PLANNING BOARD MEETING AGENDA

Thursday June 4, 2020

- Site Plan Review. Adult Use Marijuana Cultivation Facility. 11 Pond Road (R70-16) RC/I Zone. CAF Realty of Maine.
- Site Plan Amendment. Commercial Storage. 387 School Street (R54-4) R2 Zone. PK Storage, LLC.

Figure 1: From School property boundary

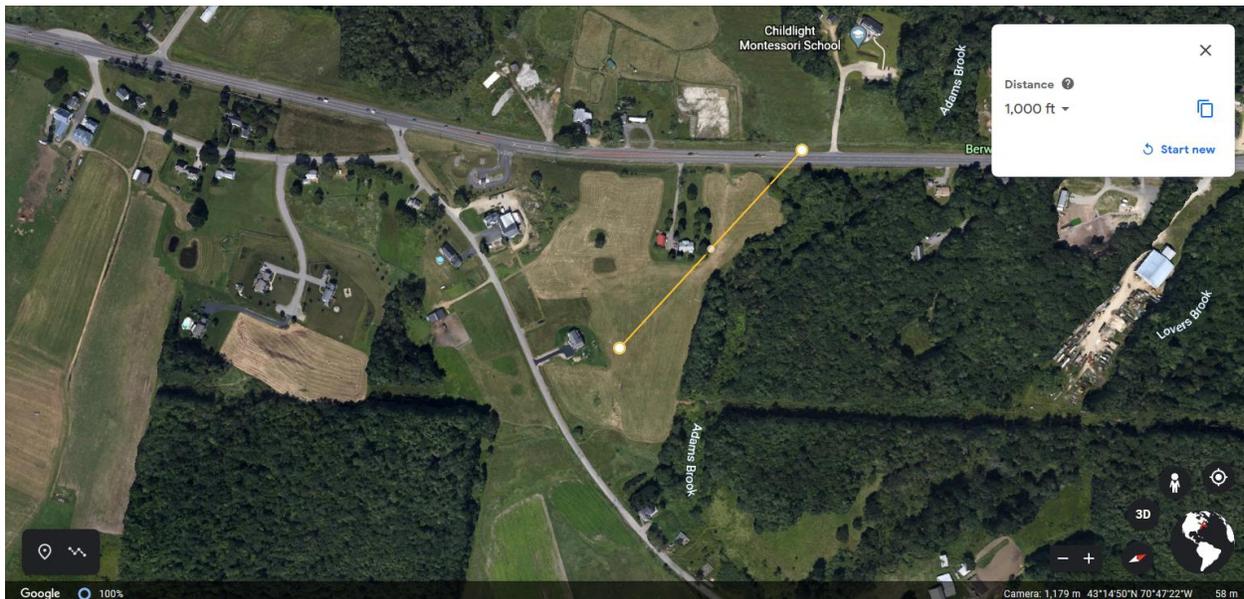
In reviewing Drawing C2 of the application, it does not show the starting point that is used to measure the 1,000 feet distance from Childlight Montessori School to the proposed building(s). What is the applicant using as a starting point? Based on research using Google Earth and comparing it to Drawing C2, it does not appear that the 1,000’ requirement is met if the starting point is located at the property line. Please see attached Google Earth Screen Shot showing the distance. At the site walk on May 7, 2020 the engineer provided a diagram that showed a revised 1,000’ radius. The revision reduced the original distance from 1,050’ to approximately 1,009’ per the engineer’s comments.

Due to this discrepancy, we respectfully ask that a third party verify the distance from the Childlight Montessori School and Kind Farms to ensure compliance. Our review using the scale on the revised diagram does not show the 1,000’ setback is met.

- *Yes, the proposal meets the 1000' setback and the setback radius are shown on the plans. In addition, the licensed land surveyor has located the property boundary of the Montessori School and provided an additional plan showing the setbacks.*
